**PLANNED UNIT DEVELOPMENT
STAFF REPORT****Date: June 21, 2007**

DEVELOPMENT NAME Hancock Bank

CONTEMPLATED USE Planned Unit Development Approval to allow shared access between two building sites.

SITE PLAN

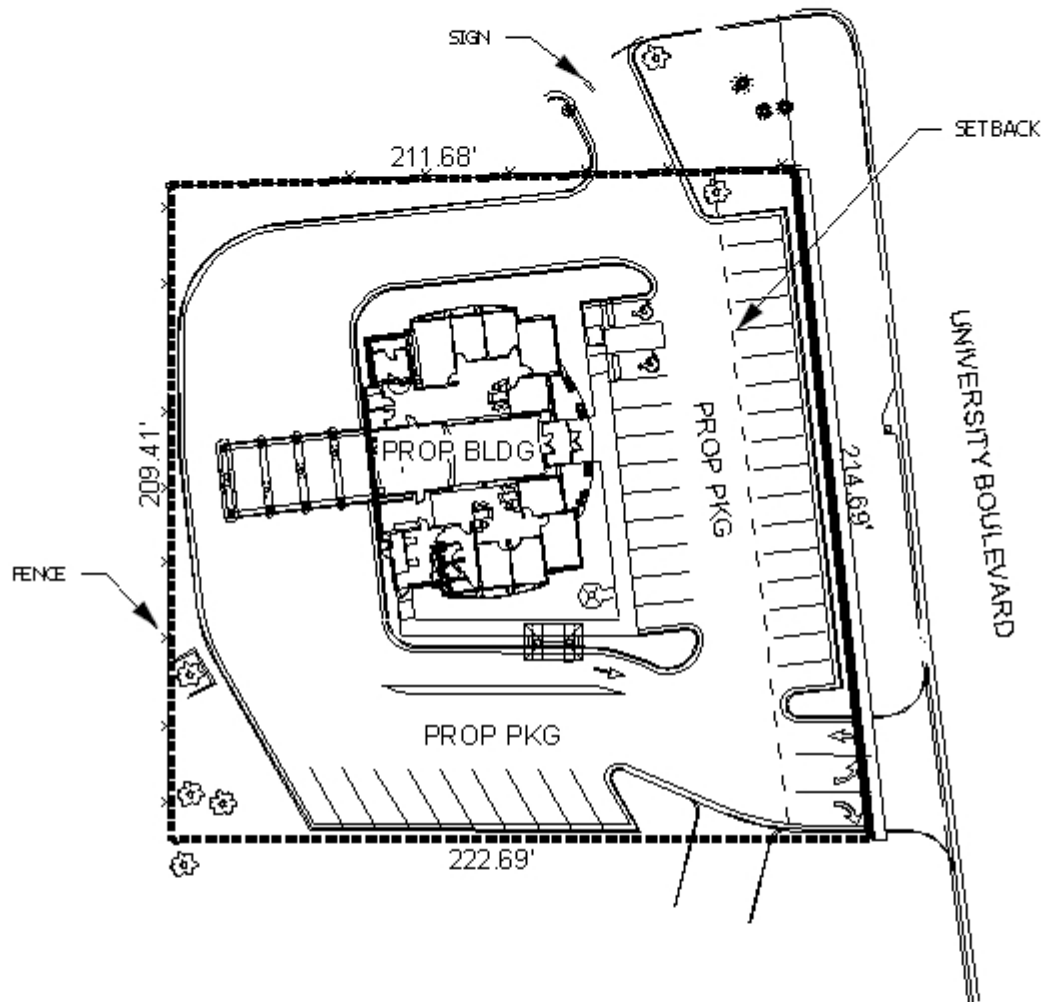
The plan illustrates the proposed building, landscaping, sidewalk, and 38 proposed parking spaces. However, the plan does not illustrate compliance with the tree planting requirements of the Ordinance.

In general, the plan appears appropriate for Planned Unit Development approval. Parking and circulation seem to be coordinated and orderly between building sites. In fact, during construction of the permanent building, the location of the temporary modular building would allow sufficient maneuvering area in which a vehicle could travel between both sites.

Another area of concern is mentioned in Urban Forestry Comments and should be included in the conditions of approval. Preservation status must be given to the 52" Live Oak Tree located on the East side of proposed drive between building sites. Any work on or under this tree is to be permitted and coordinated with Urban Forestry; removal to be permitted only in the case of disease or impending danger. Additionally, the construction of the drive complies with Notes as stated on the submitted Planned Unit Development (PUD) plan.

- 1) area to be paved with permeable material;
- 2) tree root system is not to be disturbed;
- 3) tree trimming to be performed by an Arborist; and
- 4) all work and materials is to be coordinated and permitted with the City of Mobile Urban Forestry Section.

- 1) the compliance with Urban Forestry Comments, (Preservation status is to be given to the 52" Live Oak Tree located on the East side of proposed drive. Any work on or under this tree is to be permitted and coordinated with Urban Forestry; removal to be permitted only in the case of disease or impending danger. That the construction of the drive complies with Notes on PUD plan: 1) the area to be paved with permeable material; 2) the tree root system is not to be disturbed; 3) tree trimming to be performed by an Arborist; and 4) that all work and materials is to be coordinated and permitted with the City of Mobile Urban Forestry Section); and
- 2) full compliance with all municipal codes and ordinances.
